DATE: 3/11/90
DRAWING OF WORK AS BUILT

RECORD DRAWING
OF WORK AS BUILT

Revisions as noted - As Built		Date	Approved
Revision	Description	Date	Approved
THE RBA GROUP Designed by: RBA Drawn by: JLB Checked by: JLB Submitted by: JLB Reviewed by: JLB Concurred by: JLB			
U.S. ARMY ENGINEER DISTRICT CORPS OF ENGINEERS NEW YORK, NEW YORK		SAWMILL RIVER, NEW YORK ARDSLEY FLOOD CONTROL PROJECT MIDDLE AREA FLOODPROOFING BUILDING ELEVATIONS	
Approval Recommended: JLB Approved by: JLB Concurred by: JLB		Sheet reference number: 32-100-100 Date: 20 JUL 90 Scale: AS SHOWN Sheet 32 of 40	NEW YORK 20 JUL 90

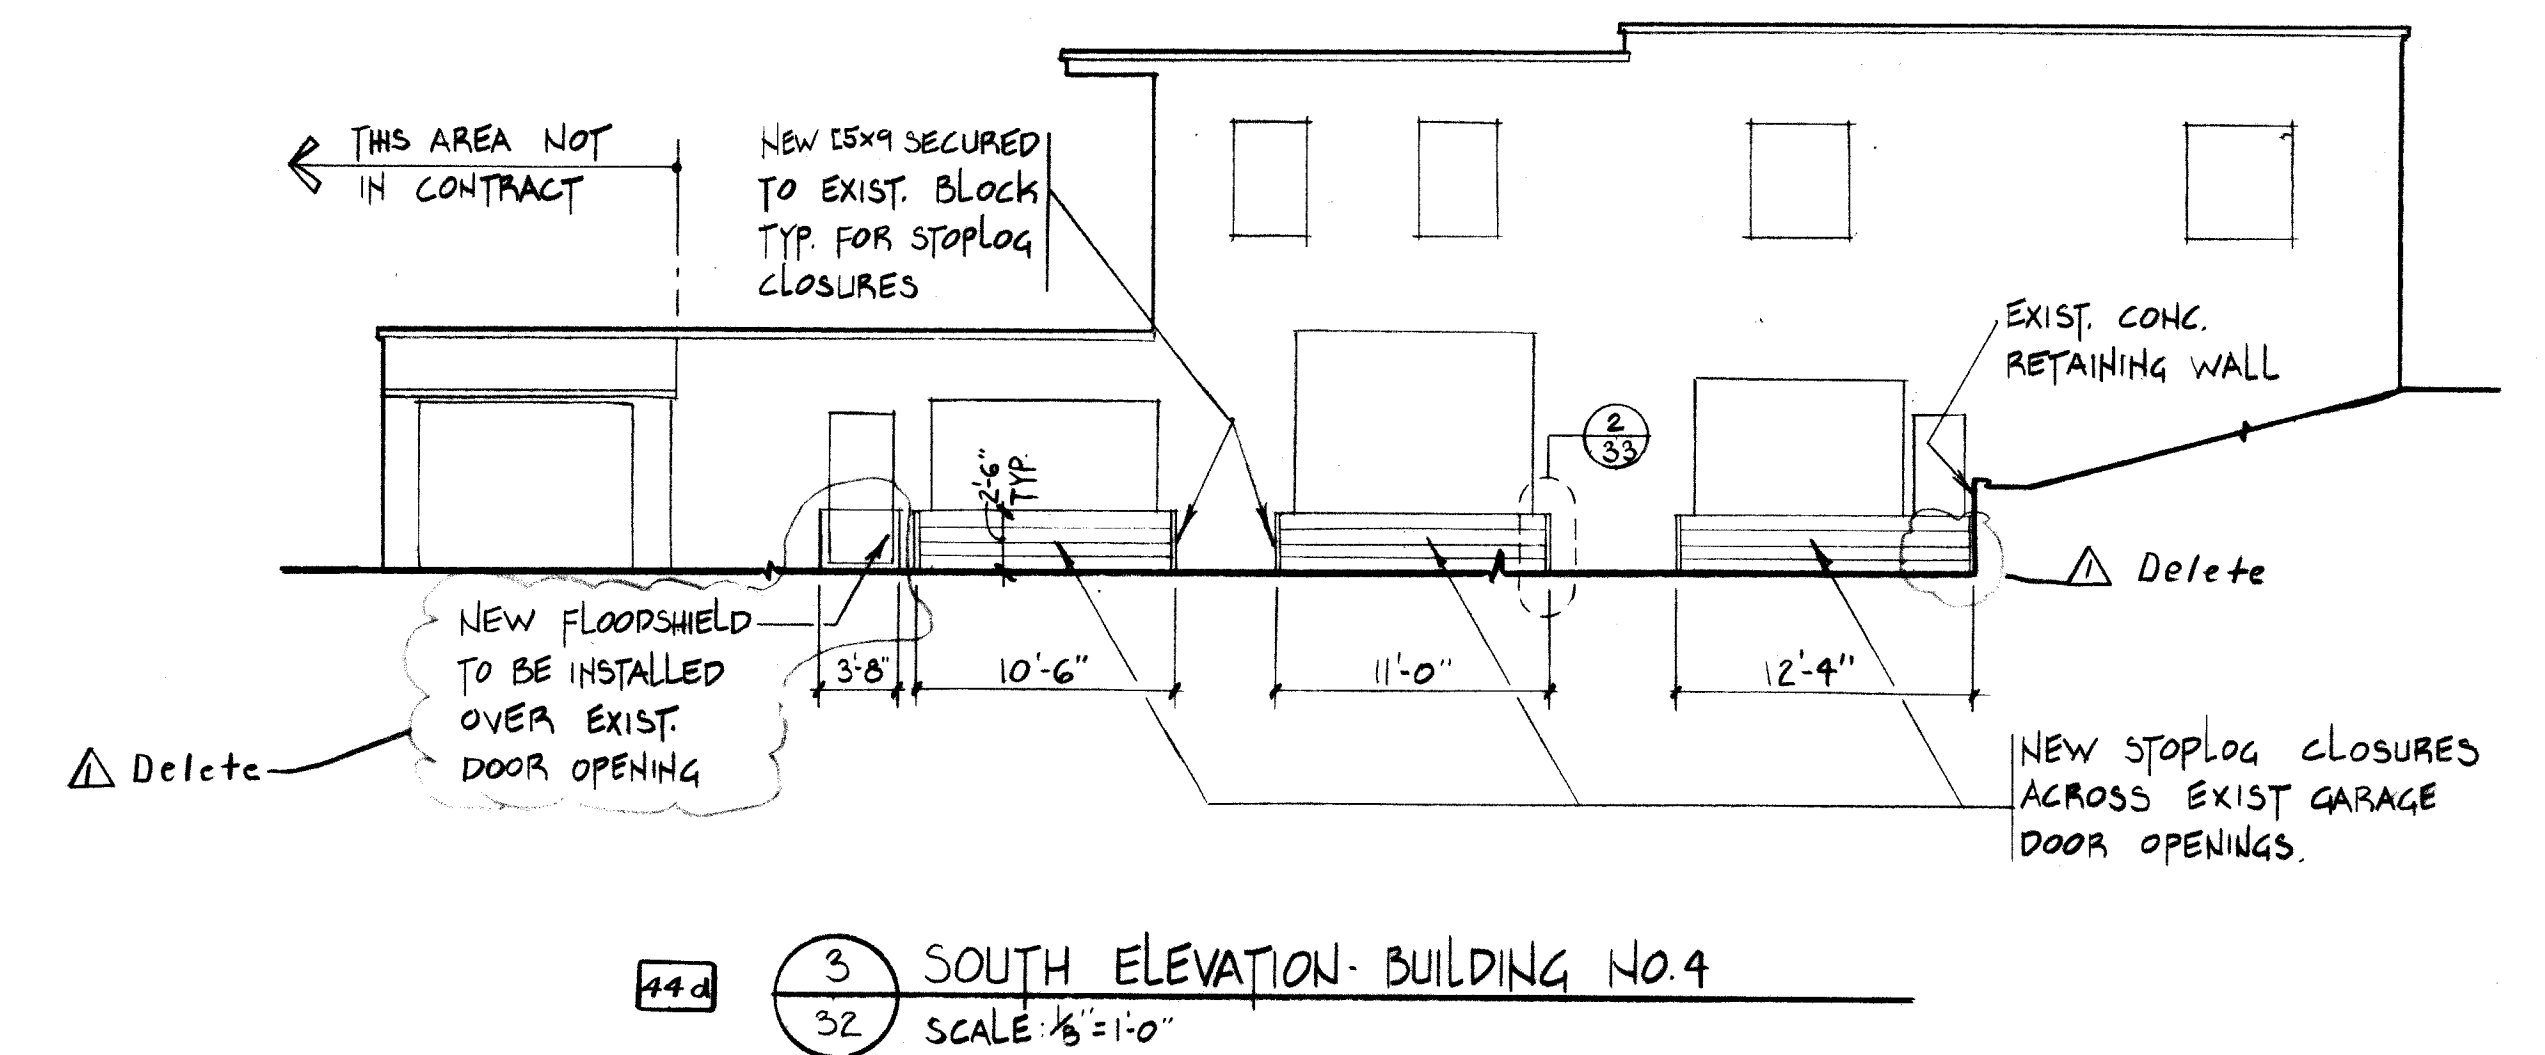
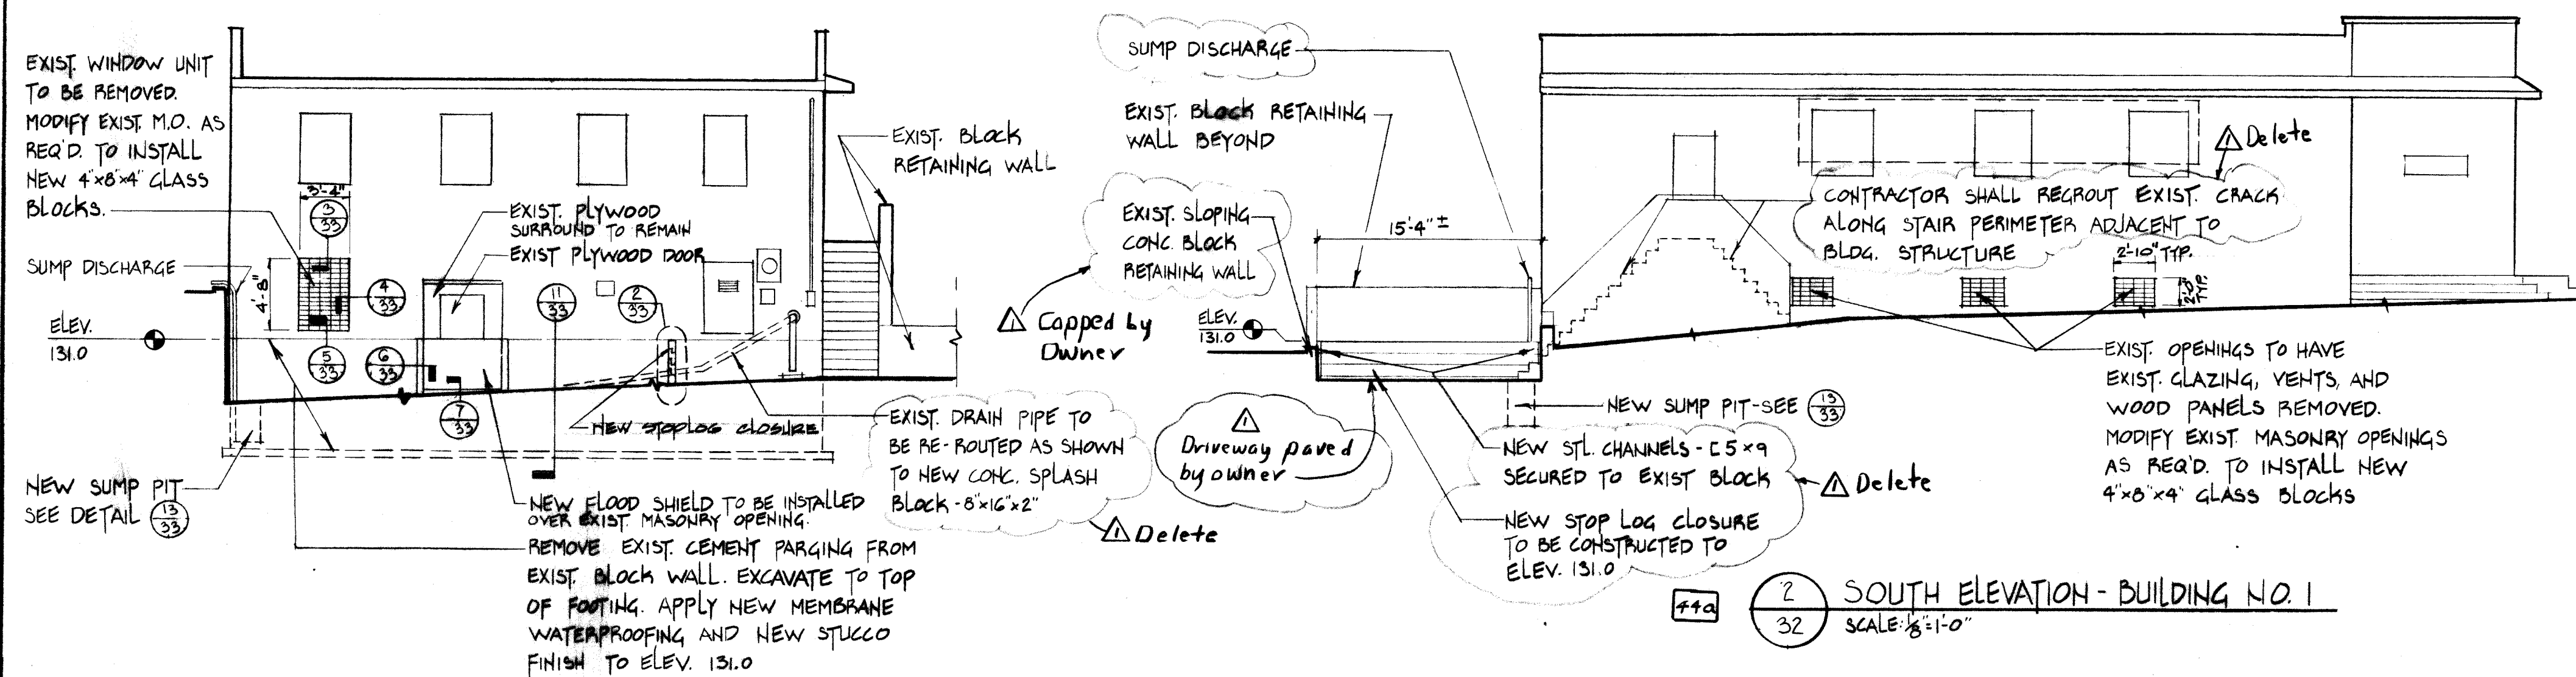
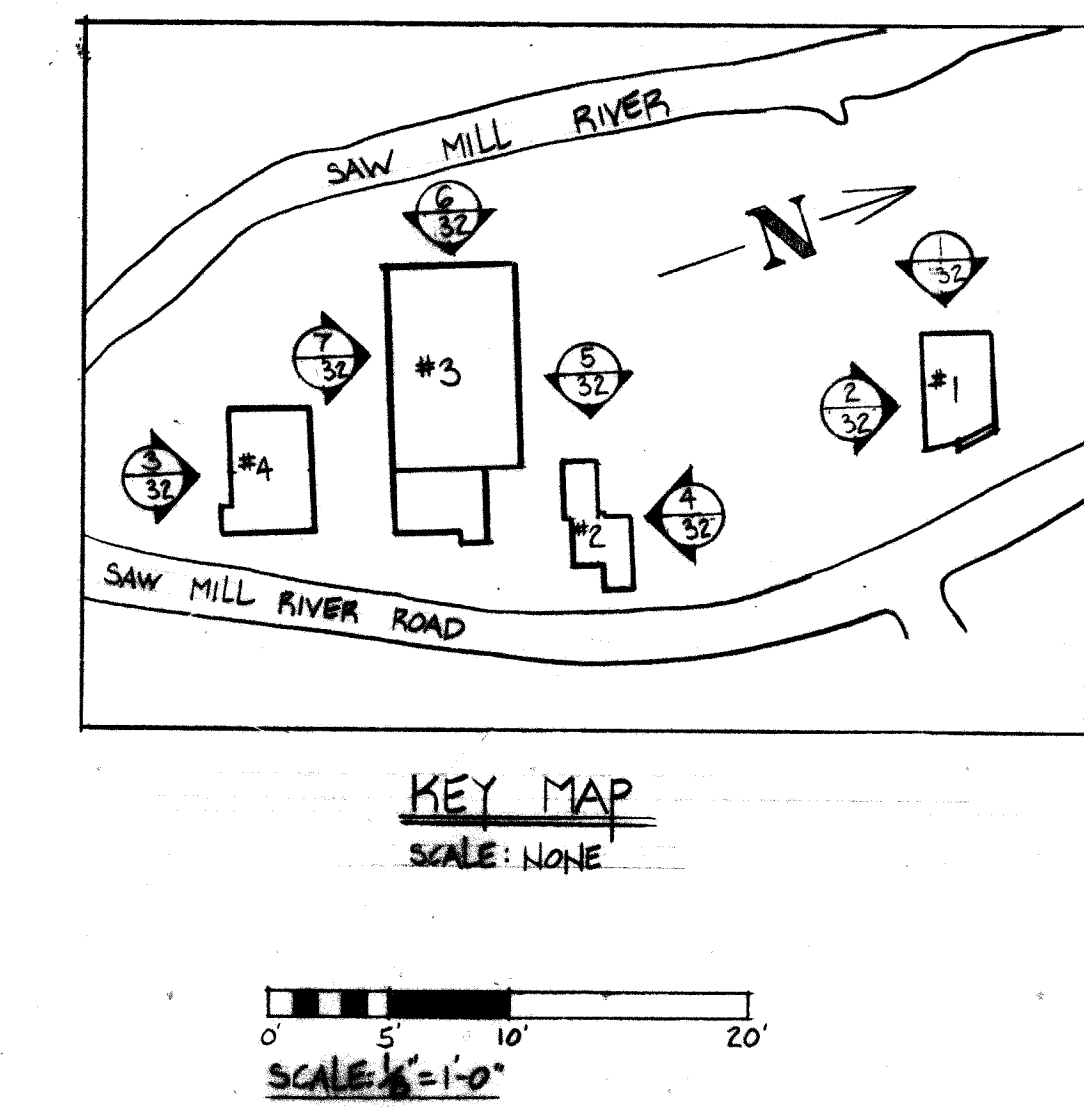
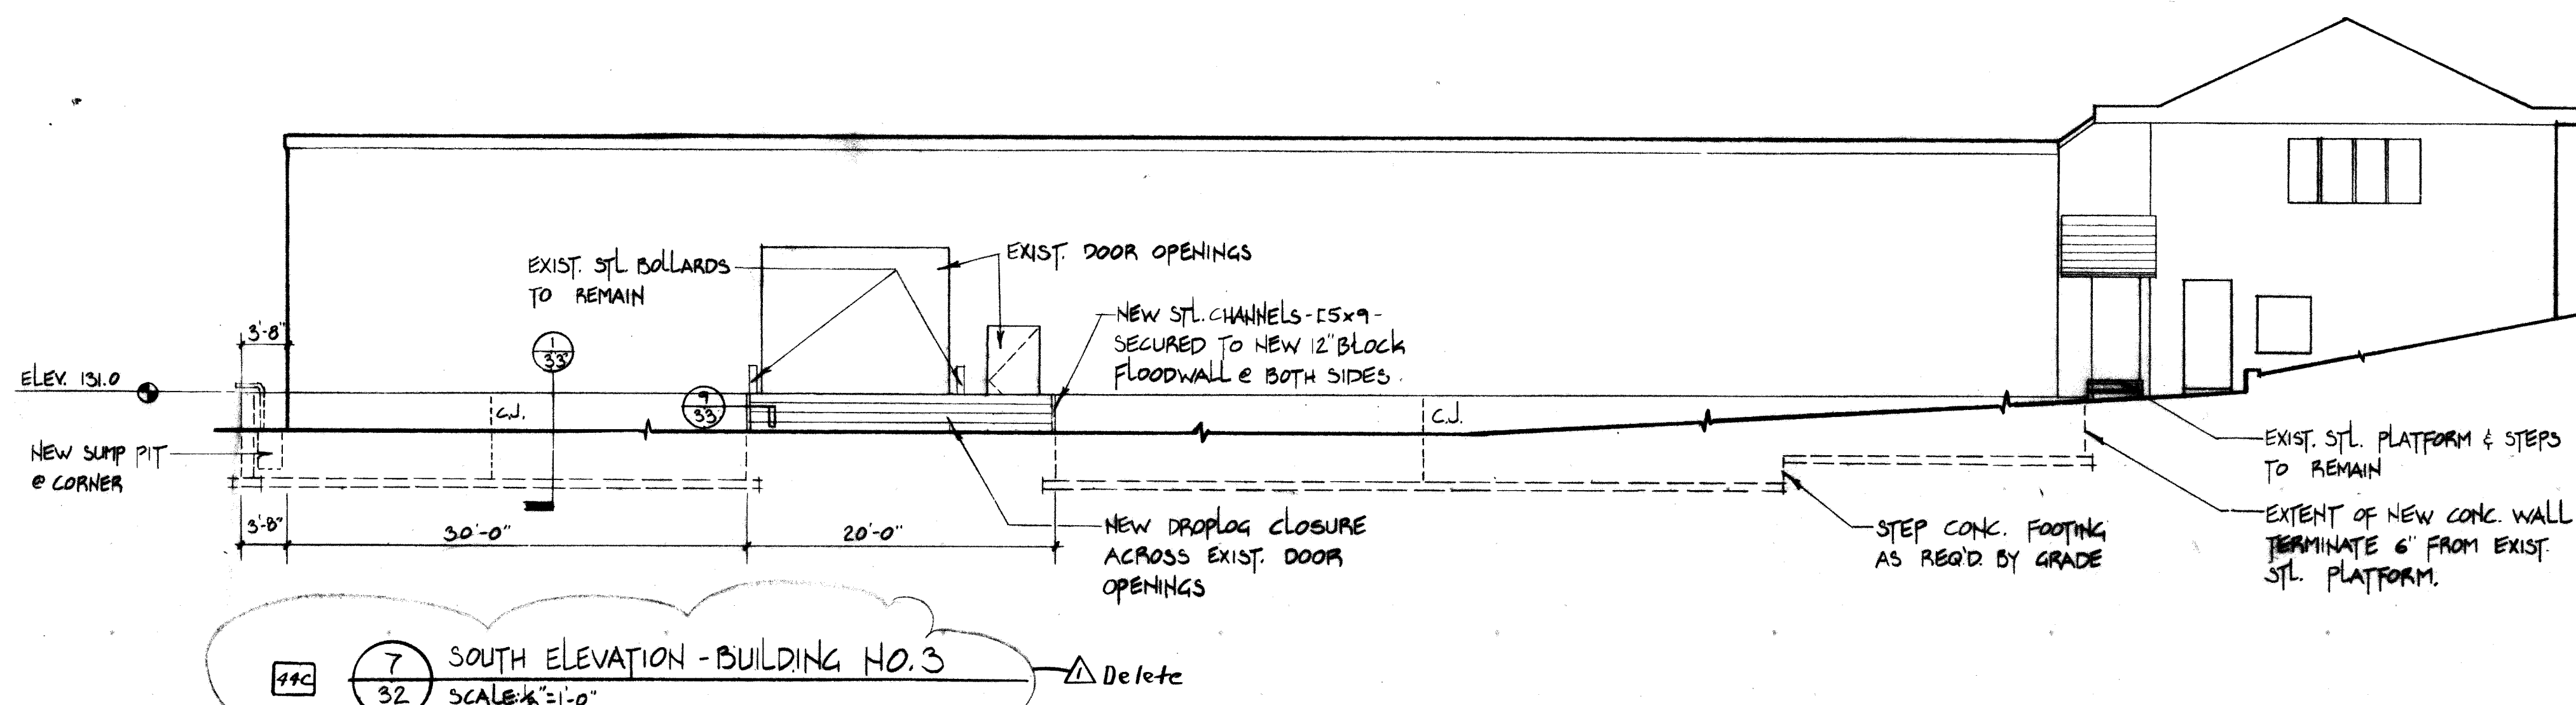
- Notes:**
- Work on Building No. 3 completely eliminated.
 - Building No. 1
 - No Stop Logs
 - No grouting along Perimeter of Stairs
 - Existing Drain Pipe to be rerouted
 - Sump to Storm Sewer piped underground
 - Delete New Sump Pit at Building No. 2. Waterproofing to South End of Building because Floodwall was deleted.
 - Building No. 4
 - New Floodshield to be eliminated
 - Stop logs must cross both Garage and Entrance. End stop logs at Garage Doors.
- Deleted due to Owner Improvements*

11 DETAIL THRU SUMP PUMP PIT
32 SCALE: 1"=1'-0"

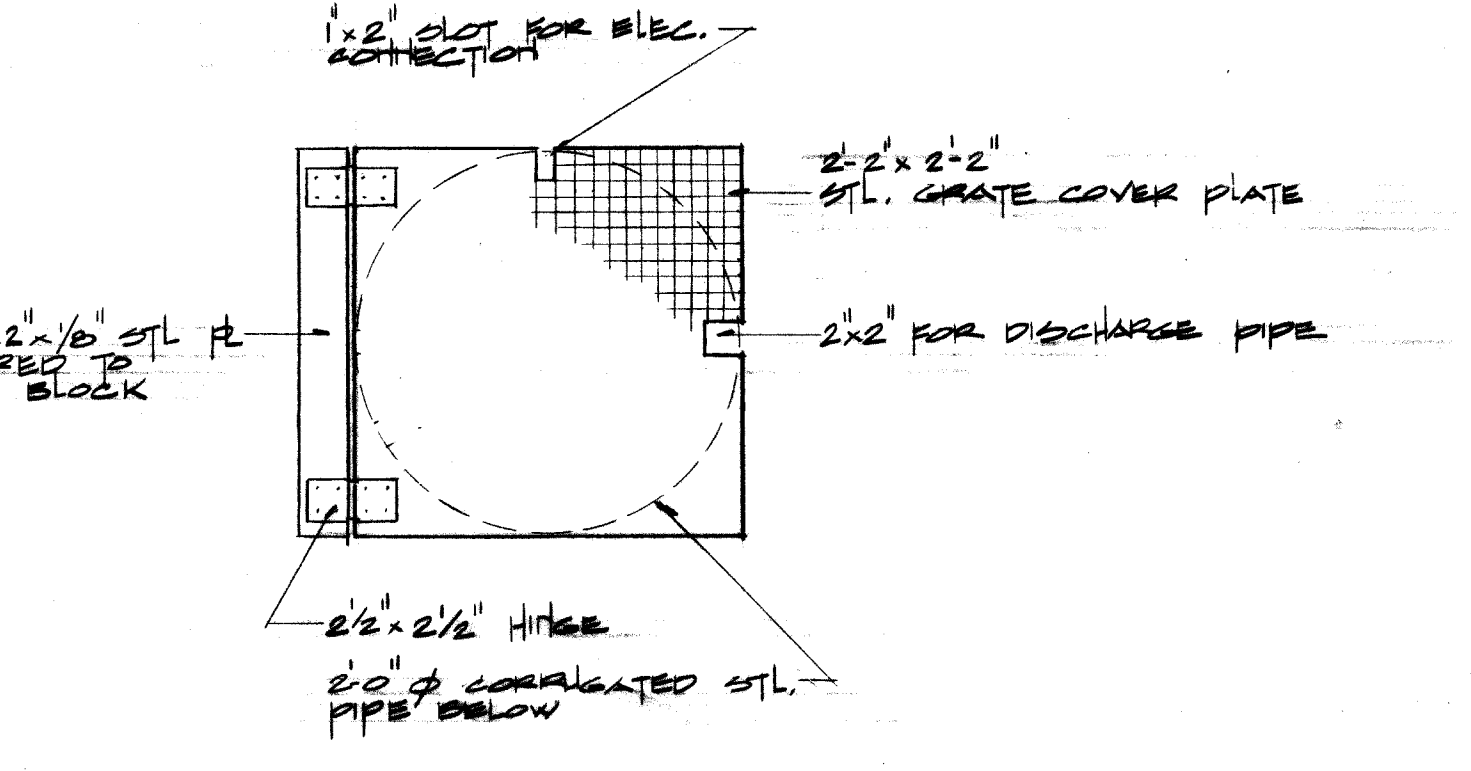
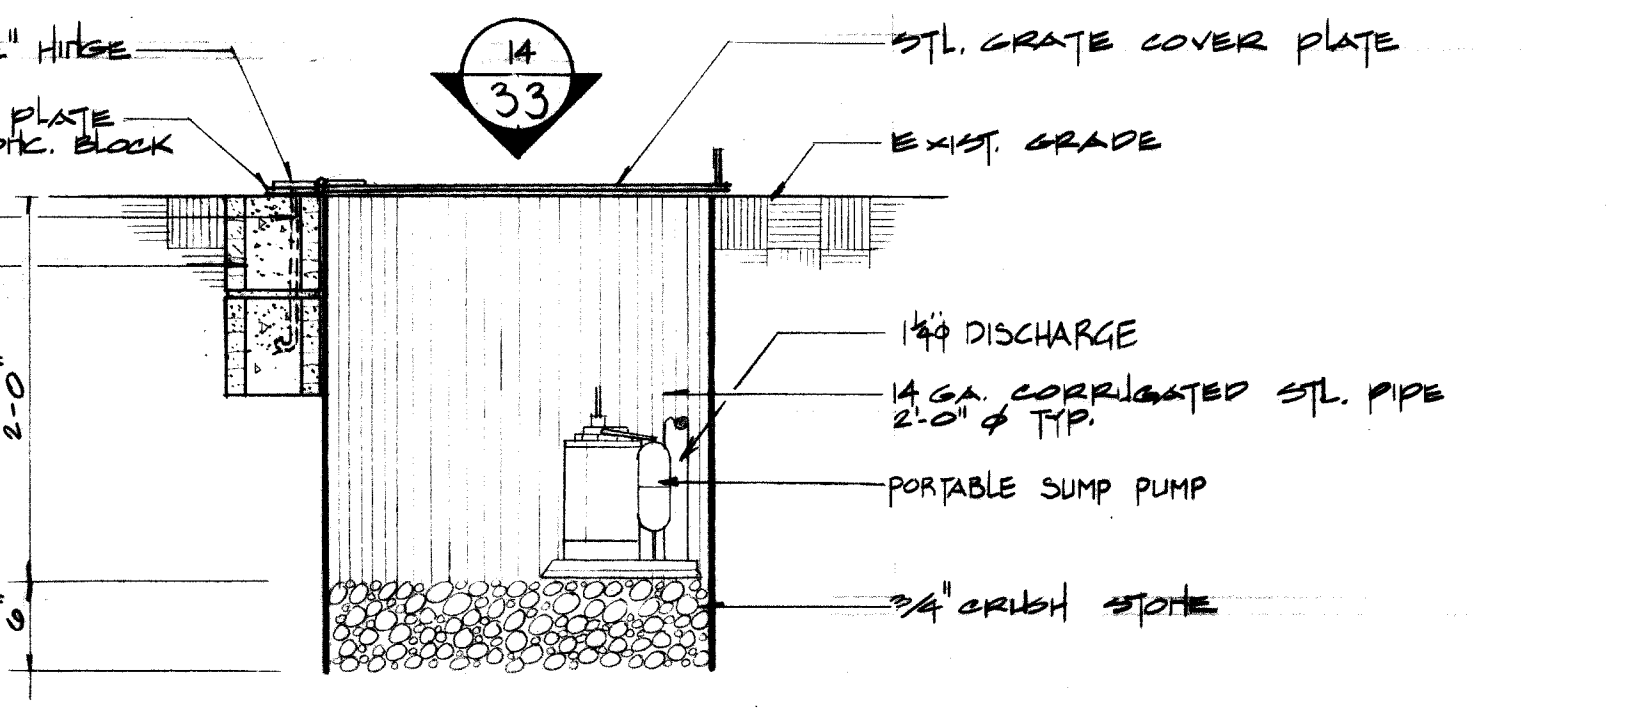
△ Delete details as per revisions noted on sheet No 32
